MODIFICATION REQUEST:
***External façade changes and amendment
to conditions to Dr Chau Chak Wing
Building
14-28 Ultimo Road, Ultimo
(MP09_0153 MOD 1)***

Director-General's
Environmental Assessment Report
Section 75W of the
Environmental Planning and Assessment Act 1979

August 2012

Figure 3: Proposed Modifications to the Eastern Elevation

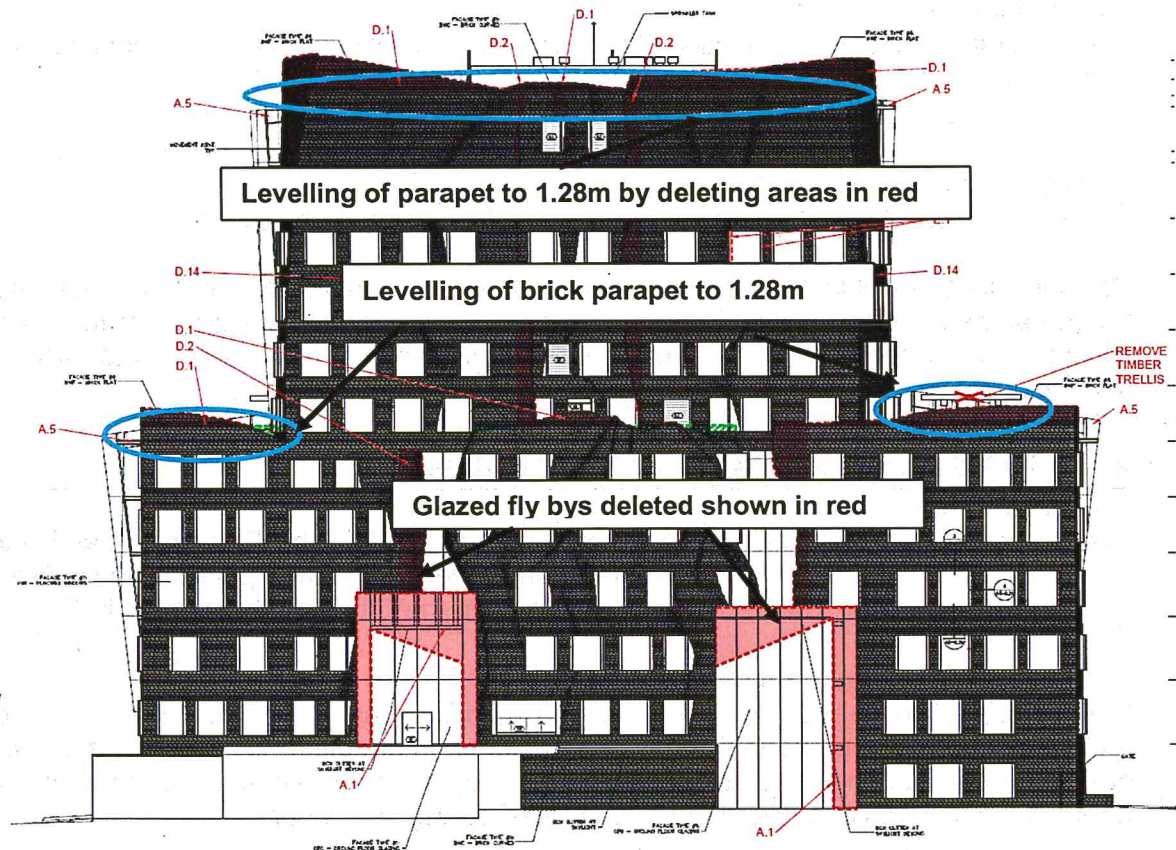
- Amend the extent of the glazed fly-bys on the western facade between Level 2 and the roof of the building.
- Flatten the sculptural brick parapets on the eastern and western elevations to a height of 1.28m on level 8 terraces and the roof level.
- Reduce the curvature of the brickwork on the eastern elevation.
- Modify the configuration of office rooms on levels 6 and 7.
- Reconfigure the amenities and increase the number of bicycle parking spaces within the basement car park from 155 to 171.

- Levelling the parapets on the eastern and western elevations will provide the building with a more traditional warehouse form. Furthermore, the proposed modification to the parapet walls will not result in any adverse wind or safety impacts on the level 8 terraces.
- The reduction in the scale of the glazed fly-bys will not result in a significant reduction in the level of transparency in the western elevation. Furthermore, the scale of the fly-bys will still enable images of the surrounding buildings to be mirrored on the façade.
- Changes to the geometry of the brickwork will not reduce the sculptural quality of the eastern and western elevations.
- The application would result in a net increase in the number of bicycle parking spaces provided on site (from 166 to 179).

Figure 8: Car Park Crest and Flood Gate Details

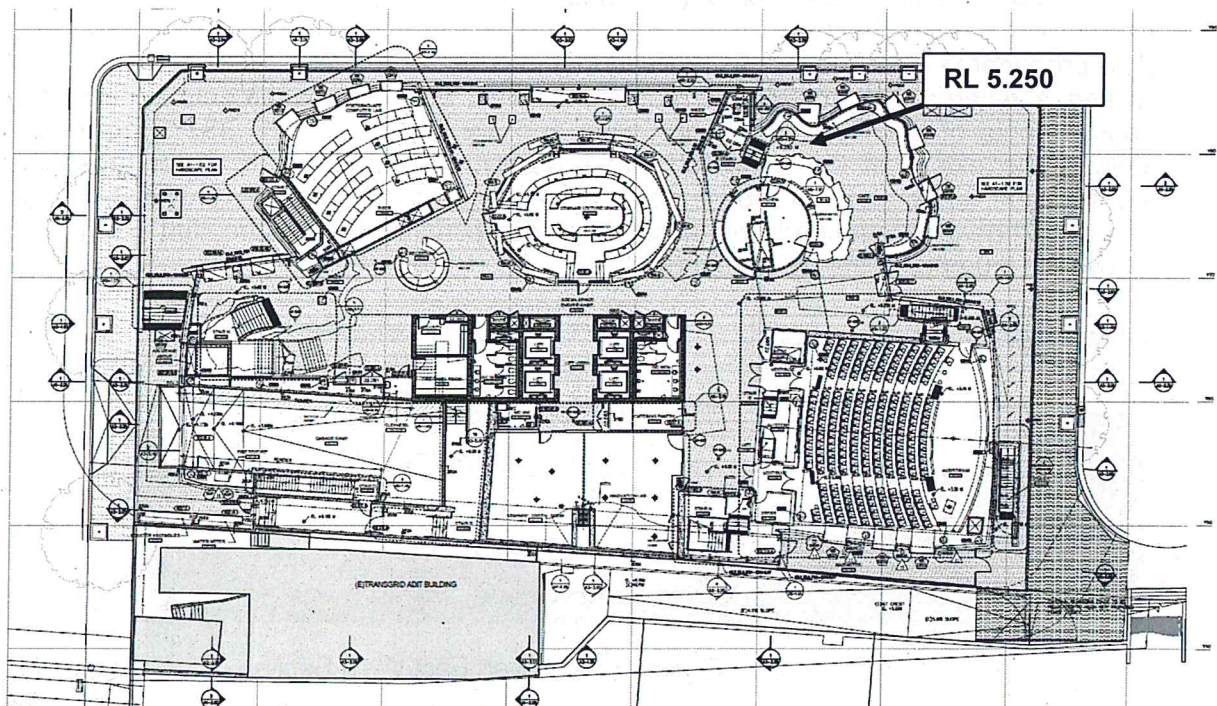
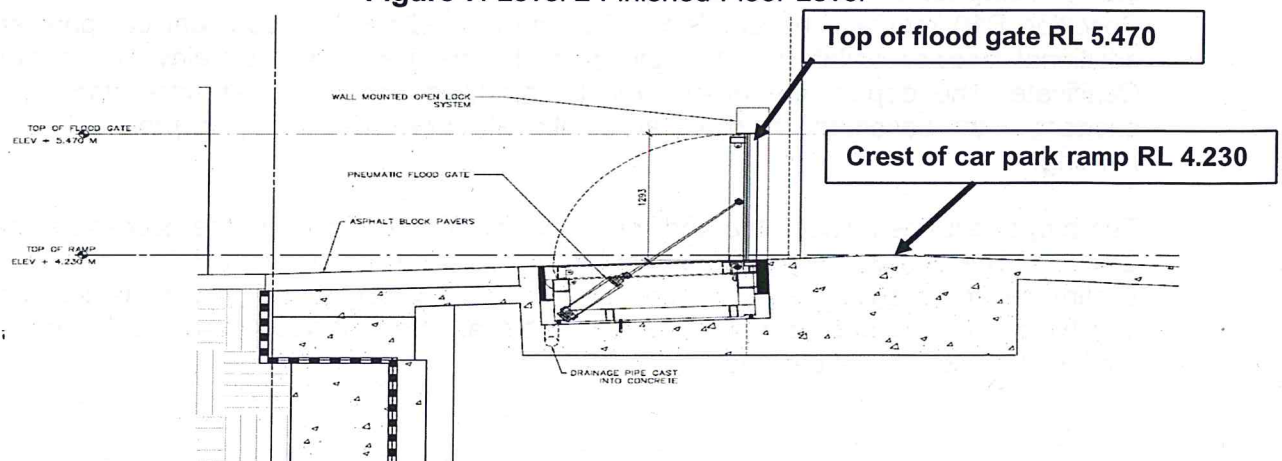
The Flood Risk Assessment dated 17 October 2011, recommended flood mitigation measures to ensure adequate flood protection is provided. This included setting a flood planning level (FPL) of RL 5.170 at second floor level (previously ground level), and RL 5.180 at the crest of the car park entrance ramp. The department considers the revised plans comply with the RLs specified in the Flood Risk Assessment, as the finished floor level of the second floor is RL 5.250, the crest of the basement car park ramp is RL 4.230, and the flood gate at the car park entrance achieves a level of RL 5.470 (see **Figures 7 and 8**).

The department notes that due to a typographical error, Condition B27 is inconsistent with the recommendations of the Flood Risk Assessment. Accordingly, re-wording the condition to reflect the requirements of the Flood Risk Assessment is supported.

The basement car park shall be protected by flooding through the use of flood gates at the car park entry and at the northern stair. The crest of the ramp shall be RL 4.230 with the top of the ramp flood gate no lower than RL 5.470. The floor level of the northern part of the building shall be no lower than RL 5.250 & the floor level of the southern part of the building shall be no lower than RL 5.000.

*In addition, the final plans must include the installation of a hydraulically operated flood gate to the basement car park. Details demonstrating compliance with the abovementioned requirements must be provided to the satisfaction of the Certifying Authority prior to the issue of the first **Section 109R Crown Certificate**.*

Figure 9: Approved East-West Section

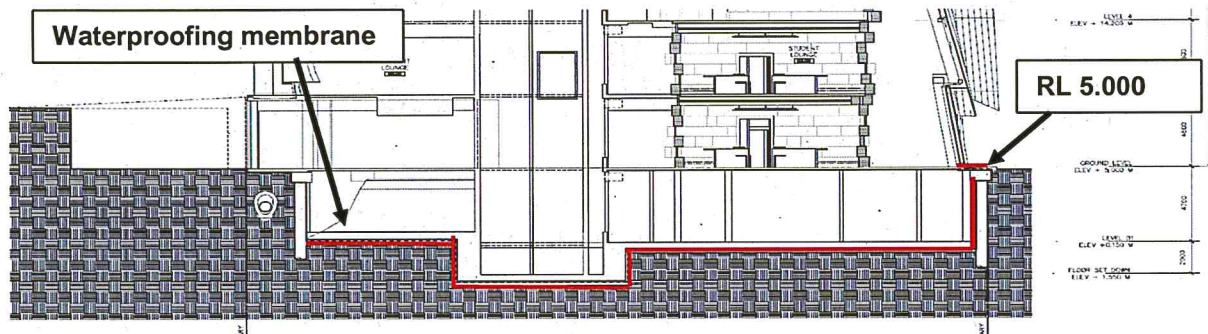
This proponent's Site Auditor has advised that in order for a Site Audit Statement (SAS) to be issued, a waterproofing membrane must be installed within the basement car park as per the requirements of the Remedial Action Plan approved under D/2011/882. **Figure 9** below depicts the extent of the approved water proofing membrane. In order to ensure that construction works above the basement car park are not commenced until a SAS is issued, the department recommends modification of the condition to ensure that no works occur above RL 5.0 prior to the issue of a SAS.

*Following the completion of remediation works covered under development approval D/2011/882, and prior to the commencement of the **relevant works**, a Section B Site Audit Statement, prepared by the NSW EPA accredited site auditor, must be submitted to the Director-General and the Council.*
